Submission to Western Harbour Tunnel and Warringah Freeway Upgrade EIS 30th March 2020

Objection: Western Harbour Tunnel and Warringah Freeway Upgrade - SSI-8863

Anna Bragg
President P&C
Cammeray Public School P&C

Figure 12-22 Annual mean PM_{2.5} concentration at community receivers
7 µg/m³ legislated by 2025

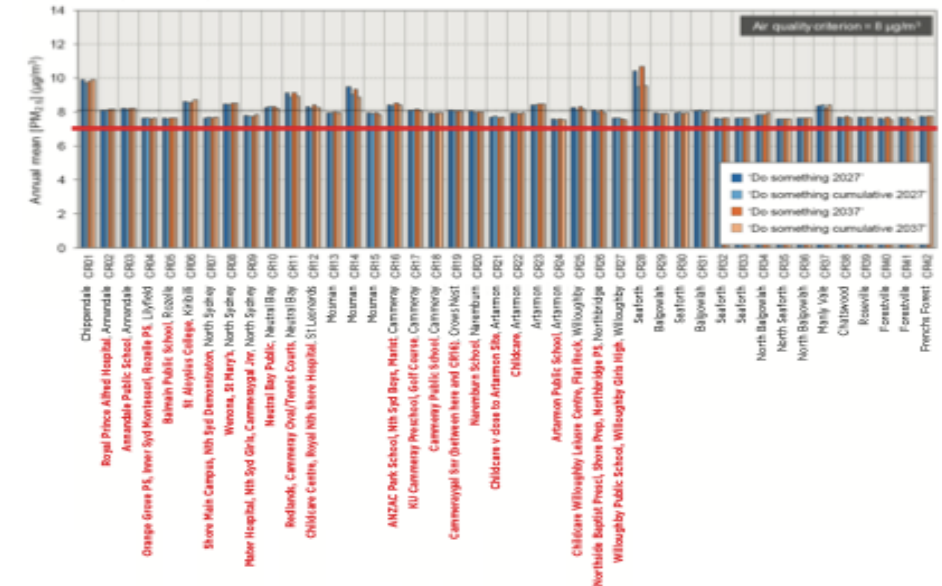
Pollution: (Here [for a summary table of pollution impacts](#)): The ventilation stack servicing the 6.5km stack at Cammeray will not be filtered. The EIS demonstrates concerning impacts in terms of pollution for CPS and its' catchment. All areas will see overall PM2.5 levels well about national criteria when project opens. CPS will experience increases in pollution across NO2, PM10 (annual) and PM2.5 (which WHO states no safe limit). Concerningly our local parks will also be impacted by increased pollution including Green Park, Cammeray Oval, St Leonard's Park and Bicentennial Reserve. Children are most susceptible, particularly at higher respiration rates. The stacks have no emergency ventilation outlets and so fumes from any high pollution events or emergencies will be dispersed over schools in the area. A summary of the CR sites that show an increase in pollution across both projects is attached. Air pollution has been averaged out across a wide span of CR sites which appear unrelated to the Western Harbour Tunnel. As no traffic analysis has been done on Willoughby Rd for example it is hard to claim Roseville is impacted. FOR WHT only relevant sites should be included in the analysis and results should be weighted by number of sensitive receivers. One graph has results covered by the key and the PM2.5 tables do not show the correct criteria level with criterion to be lowered by 2025. [Appendx B](#). Increased rat running due to ramp and accessibility changes will also re-distribute pollution to residential areas increasing the burden on sensitive receivers.

Reissue: the air quality analysis should be completed showing the actual risks to each school in the area (ie CR's should be weighted based on sensitive receiver) taking into account relative elevation and risk, clear information about which houses will have substratum acquisition should be published, reissue visual amenity pictures with clearer artists impressions showing actual buildings.
